DATE: June 1, 2017
TO: Members of the Planning Commission and Interested Parties
FROM: Lisa Gibson, Environmental Review Officer
Re: **Attached Responses to Comments on Draft Environmental Impact Report Case No. 2009.0159E, 1500 Market St. (One Oak)**

ONE OAK STREET PROJECT

(1500-1540 MARKET STREET)

CITY AND COUNTY OF SAN FRANCISCO
PLANNING DEPARTMENT: CASE NO. 2009.0159E

(REVISED) FIGURE 2.3: PROPOSED GROUND FLOOR PLAN

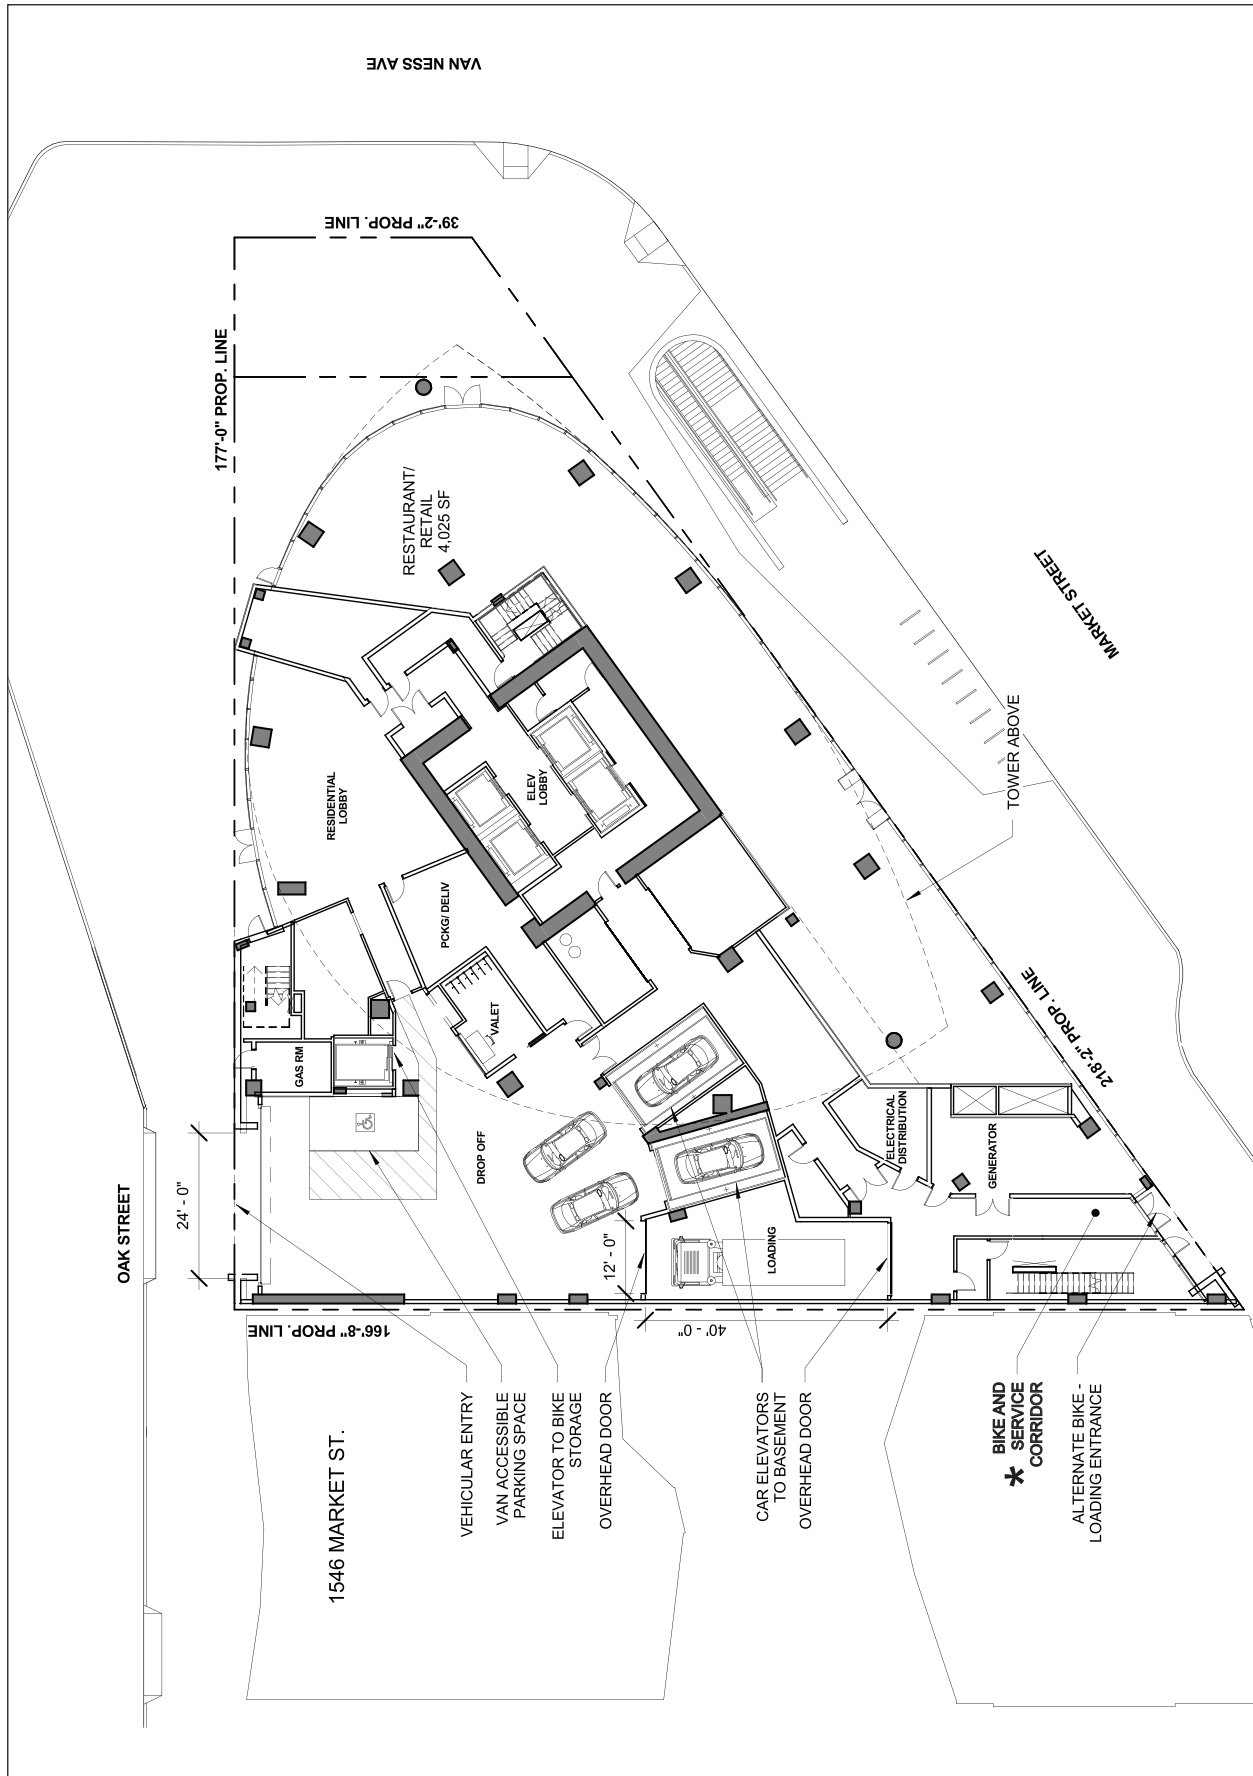
- * Figure 2.3: Proposed Ground Floor Plan, on p. 2.8, has been revised to change the label for “Loading and Bike Corridor” to “Bike and Service Corridor.” The revised figure is shown on the following page.
- * On p. 2.12, the following change has been made to the second sentence of the first complete paragraph (new text is underlined and deletions are shown in ~~striketrough~~):
